From: Joseph, Stacy
Sent: Monday, August 22, 2011 11:12 AM
To: 'ccchappell@stpegs.com'
Cc: STPCOL
Subject: Member Brown response to ACRS Action Item 87
Attachments: C Brown Response to 11_06_21 SC Mtg Action Item 87 TG OST.doc; NINA Slides TG Primary & Emergency OST 11_02_02.pdf

Figure 10.2-5 Turbine Overspeed Trip System Functional Diagram

6/21/11 STP3/4 SC Meeting Action Item 87 NINA Presentation
C Brown Response 8/10/11

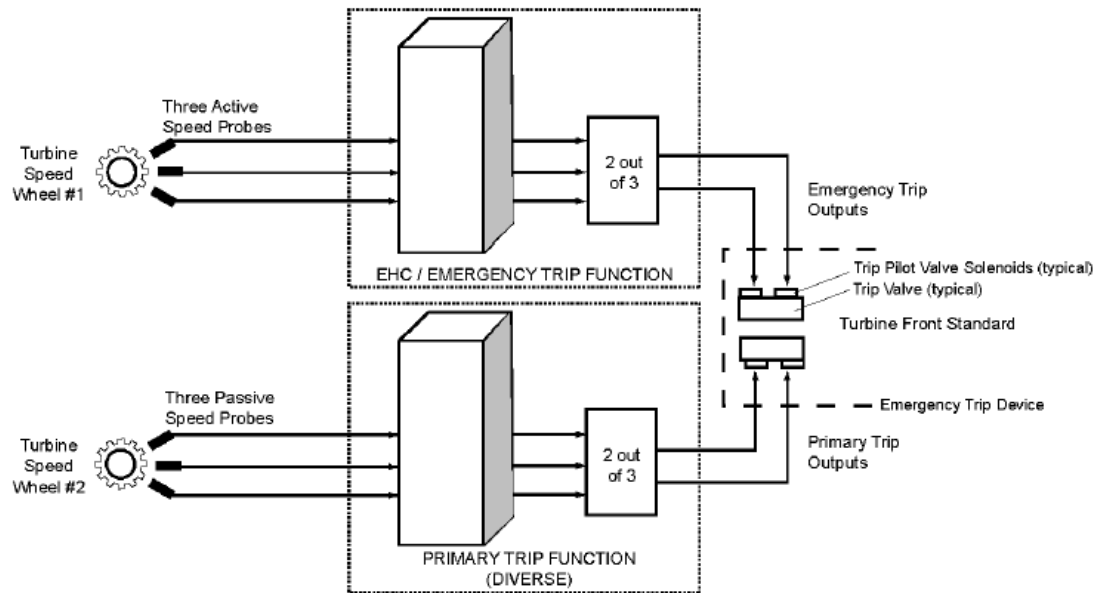
The speed sensors referenced in the last sentence are the sensors that feed the Normal Speed Control function and the Emergency Trip Function shown in Figure 10.2-5 above. They are active sensors requiring power sources.

The question I asked was "Does the loss of any two of the passive sensor signals that feed the Primary Trip Function shown in Figure 10.2-5 also initiate a turbine trip?"

I do not agree with their conclusion since they are saying that loss of signals from the passive sensors for the Primary (diverse) Trip Function doesn't matter since (see STP Action Item response presentation pages 14 and 15):

1. They do not affect the redundant Emergency OST or the Normal Turbine Speed Control, and
2. Operators will know they failed and can take appropriate manual action.

Now the detail reveals that loss of signal from two of the three sensors does not initiate a turbine trip, but the loss of two of the active sensor signals of the Normal Speed Control and Emergency Trip function does produce a trip. This seems counterintuitive.

The problem is that the same active sensors feed both the Normal Speed Control and the Emergency Trip Function. This sets up a design where a sensor common mode failure can do two things. It can tell the Normal speed control to speed up and at the same time disable the Emergency Trip Function. While the likelihood is small that will happen, I have been involved in a circumstance where it did and the system was an analog system not a software based system as is being proposed.

Conclusion 1 - Unless there is something I have missed, the Primary Trip Function must not just alarm, but that the loss of signal or failure of two of the three passive sensors should initiate a trip as well.

Primary Overspeed Trip and Emergency Overspeed Trip Functions

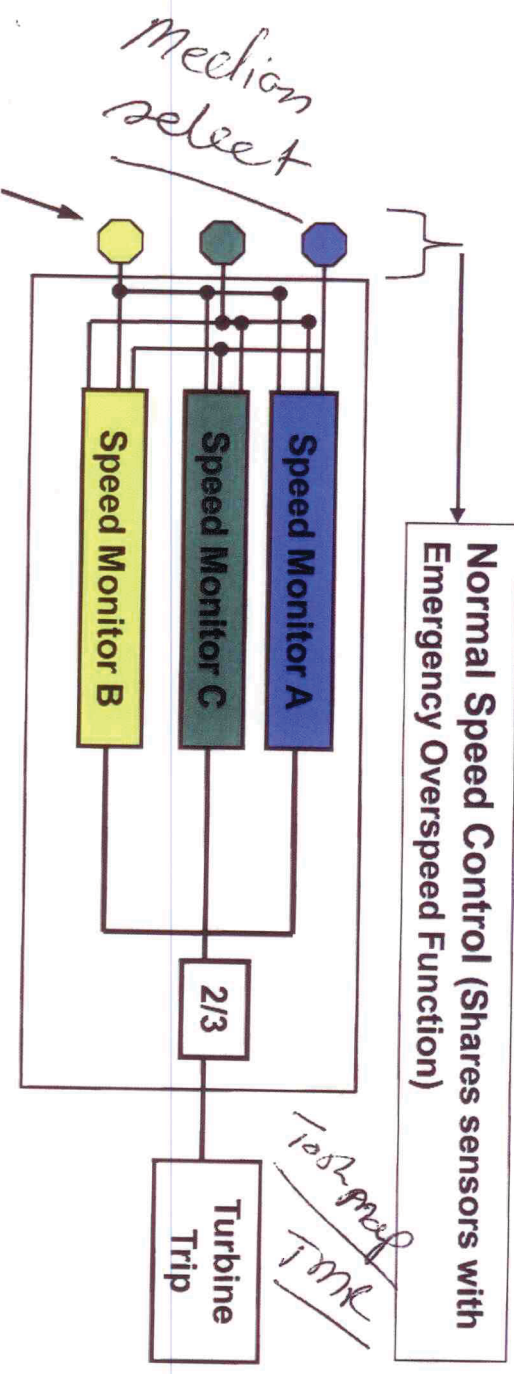
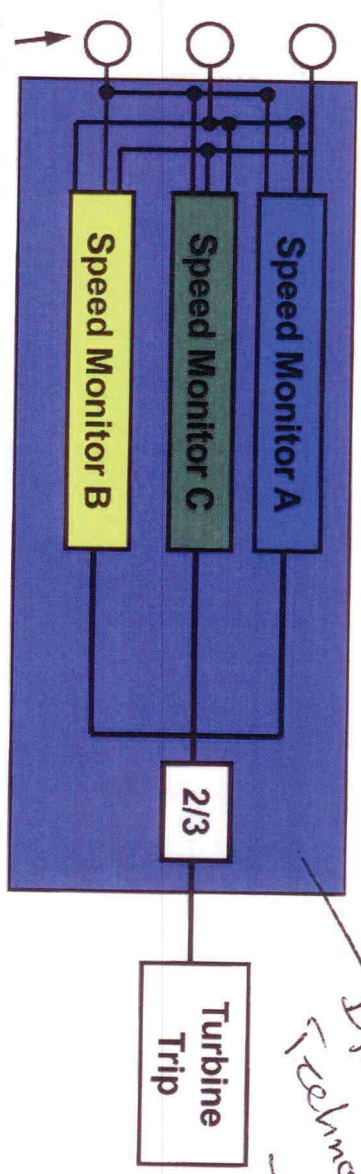
My second attachment (two slides dated 2/2/11) shows the design in more detail and further illustrates the problem. Slide 8 is an expansion of Figure 10.2-5 above showing that the trip monitor processor is independent of the Normal Speed Control processor. Slide 7 shows that each active sensor feeds all three speed monitor processors for the Emergency Trip Function further enhancing the chance for one sensor to trick all monitors, particularly since each has a power

supply that can generate garbage that can be passed through to the processors. Not shown is how these same active sensors feed the Normal Speed Control function. I suspect that it has the same three processors with each sensor feeding all three.

This makes for a very reliable stay on line architecture, which is good, but has less assurance of not having one sensor compromise not only the Emergency Trip Function, but also possibly falsely tell the TG to speed up.

Note: The Primary Trip Function also has each sensor feeding all three of the monitor processors. However, they are required to be passive and the location inside the enclosure shields them (for the most part) from stray fields.
